**A Comparison of Fibre Channel over Ethernet / Converged  
Enhanced Ethernet Proposals**

**07-336v0**

**Brocade Engineering Team**

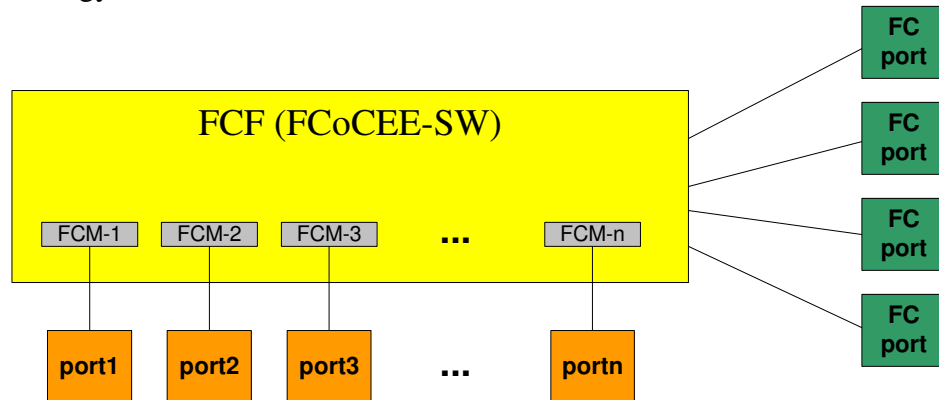
- Is there a need for defining two Types of forwarding models, one for directly connected deployment and another for in-directly connected deployment? Although FCoE provides two different models, FCoE seems to discourage usage of the Type D FCF model. 
- Does FCoCEE support both the deployments equally well with a single model. If so, does having a single model simplify user deployment? 
- FCoCEE doesn't require an Ethernet Bridge inside the FCoCEE switch. The FCoCEE model appears  support the deployments illustrated in the FCoE proposal without requiring an Ethernet Bridge.

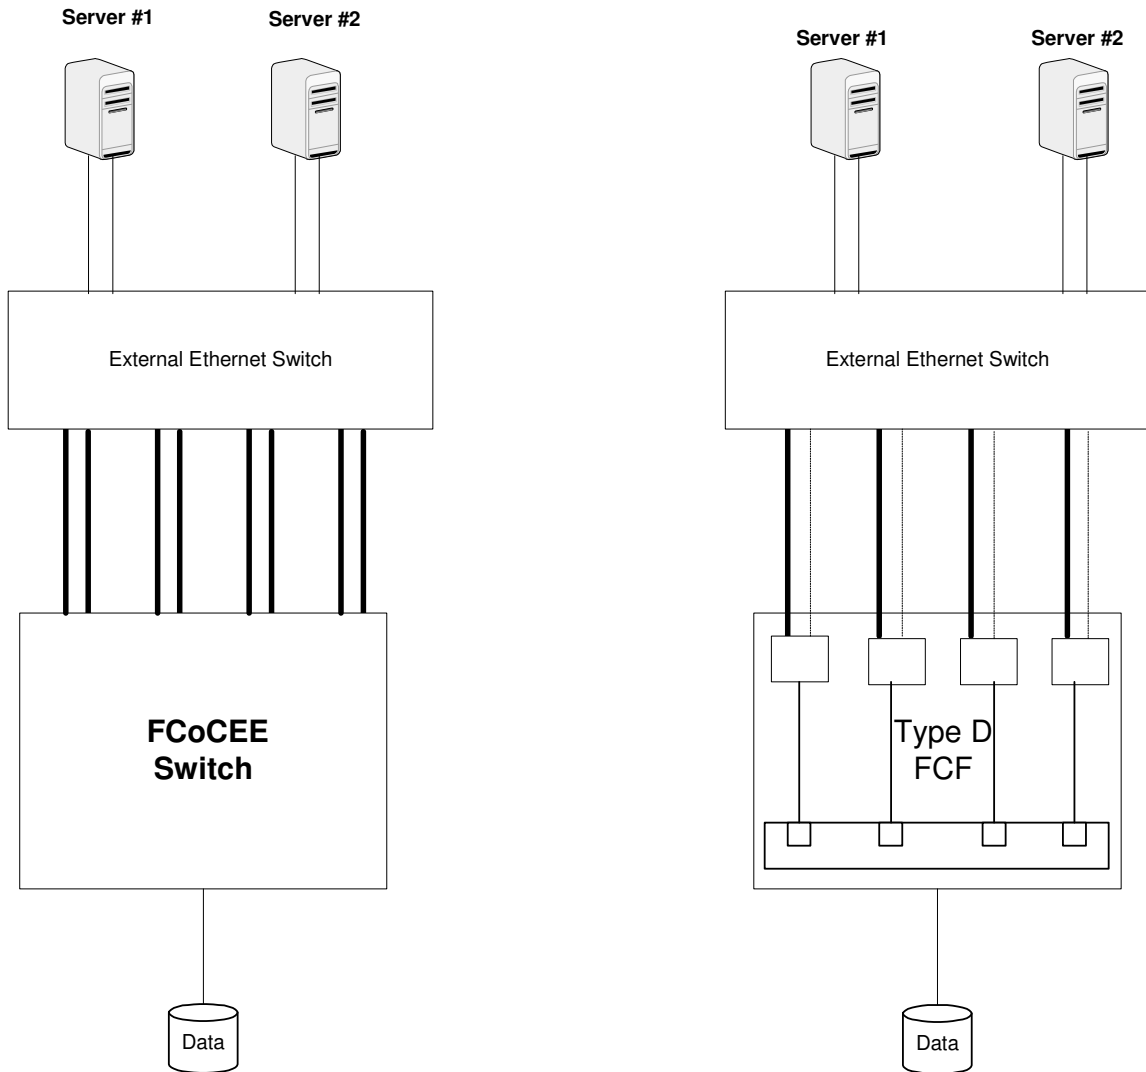
- FCoE requires spanning tree protocol to be enabled on the **EF** to eliminate the loops between the internal Ethernet Bridges and the external Ethernet switch. It appears that FCoE restricts each Internal Bridge to be in a single VLAN. It will be assumed that each Ethernet Bridge can only participate in a single VLAN. This effectively makes only one external facing port to be in forwarding state on each internal Bridge. All the other ports are in blocked mode. Ensuring multipathing in this configuration will require extensive VLAN and MSTP configuration as described below:

- c. Configure 4 VLANs. Configure each port on each bridge to be in a separate VLAN. Effectively there are four separate non-overlapping forwarding topologies between the two switches.
- d. Now, configure each FCM attached to each internal Bridge to be in separate VLANs. **Note: It's not clear in the FCoE proposal that a single FCM behind an Ethernet Bridge in a Type D FCF can participate in multiple VLANs. It will be assumed that it does not.**

- One could argue that link aggregation could be used to solve the above problem. It is not clear that this would work. Note that between a given HBA and FCM, all frames use the same source / destination MAC addresses, and there is no IP content. Therefore, there is no indication for the external switch to allow it to identify separable flows to split between the links. Consequently, even if link aggregation is enabled, it is likely that all of the traffic will flow on a single link.

- With FCoE, it is possible that the external switch will flood the FLOGI to multiple FCMs. This problem is exacerbated if one imagines multiple FCoE switches connected to the external switch. FCoE is incomplete in its specification of how this is handled.
